Re: Joshua Creek
Culvert Extension
W-N & N-W Ramps, Hwy. 403
M.P. 159-75-05, Site 10-140A
District #4

Extension to Joshuas Creek Arch Structure
and Proposed Stream Realignment

FOUNDATION INVESTIGATION REPORT

Subject: Re: Joshua Creek Structure Extension
W.P. 125-66-20, Site 10-140A
Q.E.W., District 4, Hamilton

PROP CULVERT EXTENSION
& JOSHUAS CR REALIGNMENT
BORE HOLE LOCATIONS & SOIL STRATA

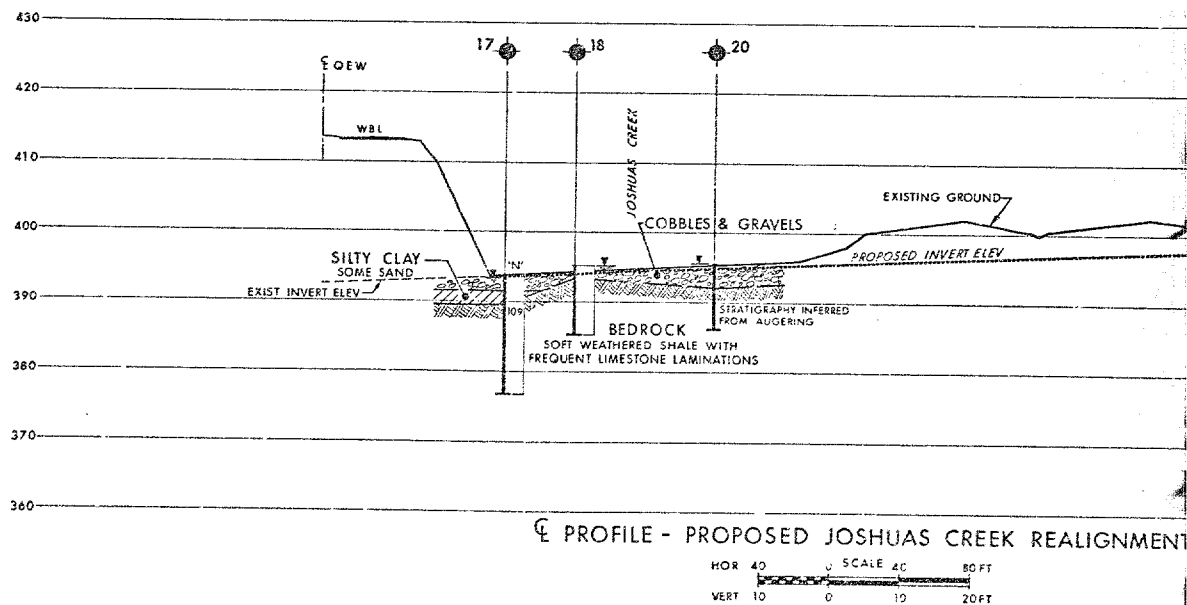
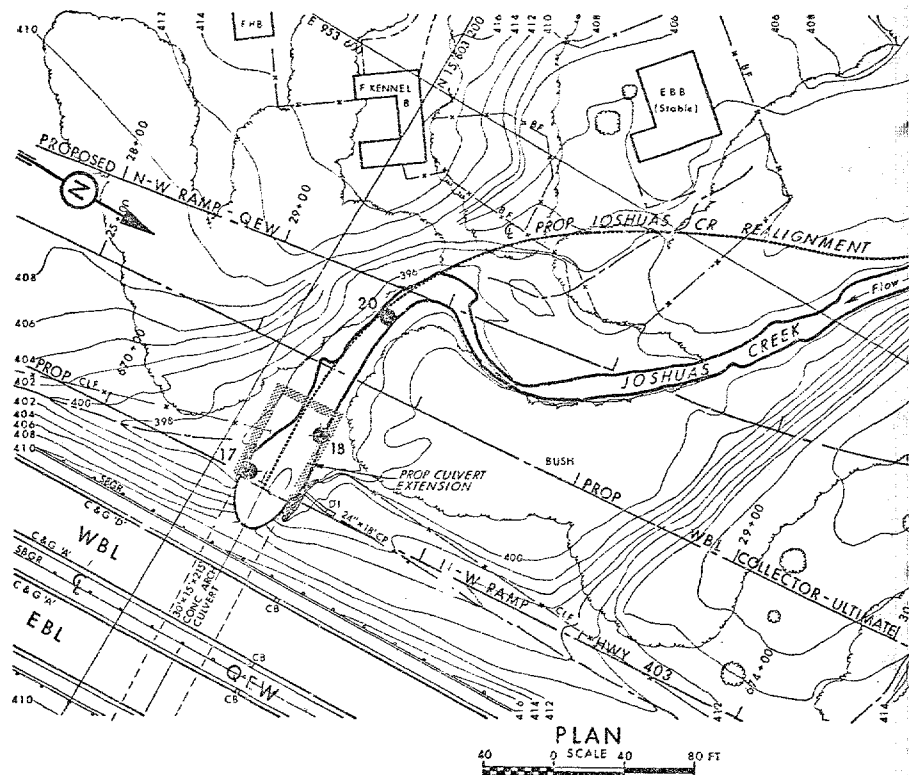
Borings were put down adjacent to the existing Joshuas Creek within the Ministry's property limits because of property restrictions as discussed in the Appendix. The locations of the borings are shown in Dwg. No. 1597505-A. In the area investigated, shale bedrock was found to exist under a layer of cobbles and gravels of variable thickness, up to 4 feet thick at certain locations. The shale bedrock was investigated to a maximum depth of $16\frac{1}{2}$ feet. In the vicinity of the existing structure, an isolated pocket of silty clay about 2 feet thick was found sandwiched between the cobble layer and the shale bedrock at a depth of 2 feet below the ground surface. A description of the soil types and bedrock is given below:

DIST 4	CONT No	No 125-66-20	SHEET
WP	No		
JOSHUA CREEK STRUCTURE EXTENSION GENERAL PLAN

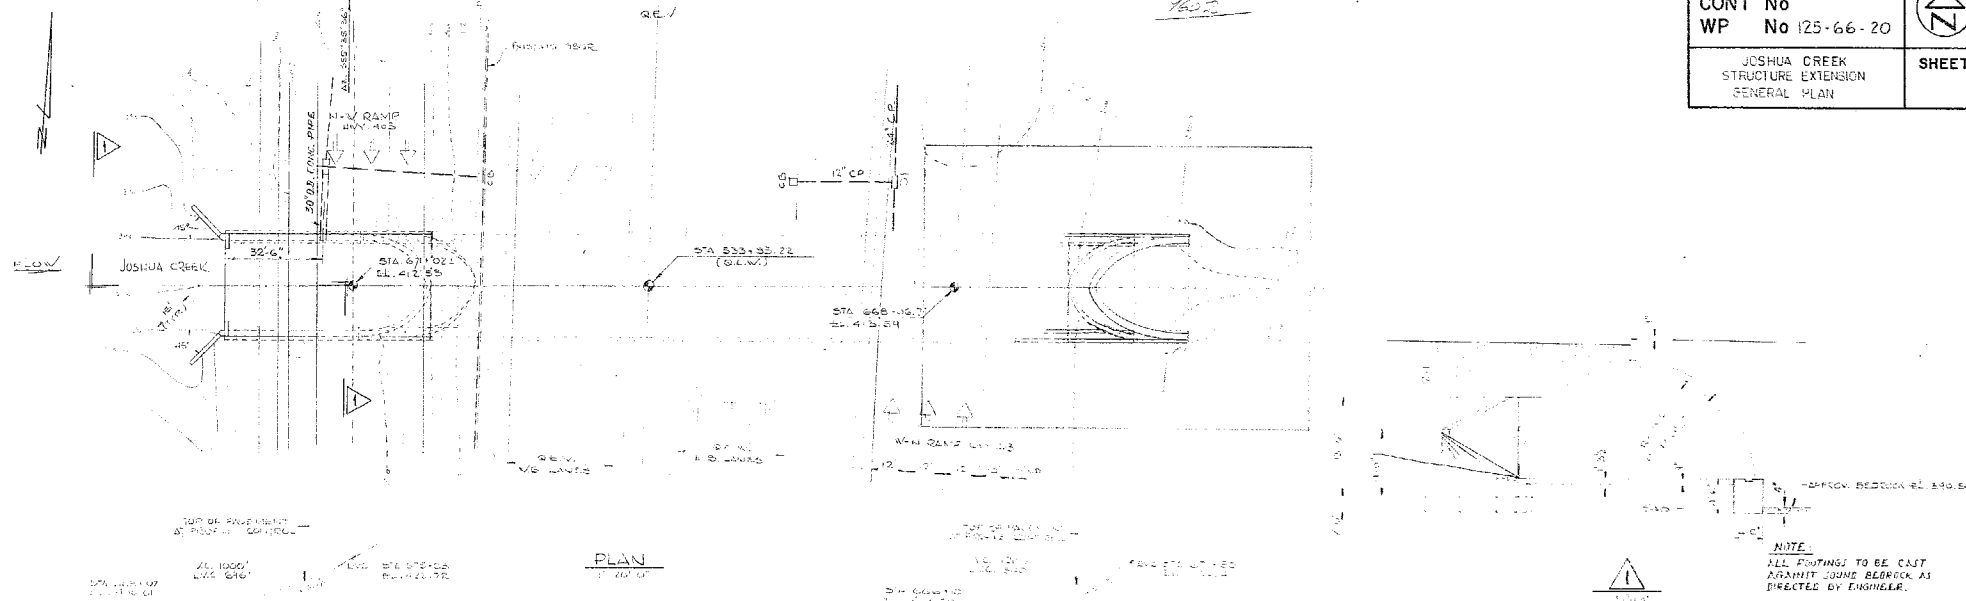
In response to your memorandum of 1978 03 29 we have reviewed the final drawings for the above structure and have the following comments to make.

At the time of the original fieldwork in June, 1977, the scope of the foundation investigation did not include the extension of Joshua Creek Culvert on the east side of the Q.E.W. A site visit made on 1978 05 25 by Mr. B. Ly of this office revealed the following condition on the east side of the Q.E.W. based on visual observations. The depth of the parent overburden is 3 to 4 feet consisting of up to 1 foot of topsoil overlying a 2 to 3 foot deposit of silty clay overlying weathered bedrock. On the north bank bedrock is exposed 3 to 4 feet above the floor of the existing concrete culvert (Reference Photo 1), whereas on the south bank weathered shale bedrock is exposed about 1 foot above the floor of the culvert (Reference Photo 2). The bedrock may be described as soft weathered shale with frequent limestone laminations. Immediately downstream of the concrete arch structure the creek widens slightly (Reference Photo 3 & 4) and it is not expected that excessive rock excavation will be required to construct the footings. Further observations indicate that the creek bed is strewn with gravel and cobbles.

For the extension to the west side the recommendations given in our report under Structure Foundations for Extension to Joshua Creek Arch Structure and Proposed Stream Realignment (W.P. 125-66-20) are equally applicable.

Furthermore, it is important to note, as discussed in the foundation report, that in the immediate vicinity of the structure the shale bedrock may have been exposed and deteriorated during construction of the existing structure. In view of this it is recommended that the footing base for the proposed extensions be inspected to determine the existence of any badly weathered material prior to construction of the footing. Any badly weathered material should be excavated and brought up to the

footing founding level by means of mass concrete. In addition, the shale in this area is very susceptible to softening by moisture. Therefore, the footing base should be covered with a 3 inch thick working slab of lean concrete immediately after excavation and inspection.
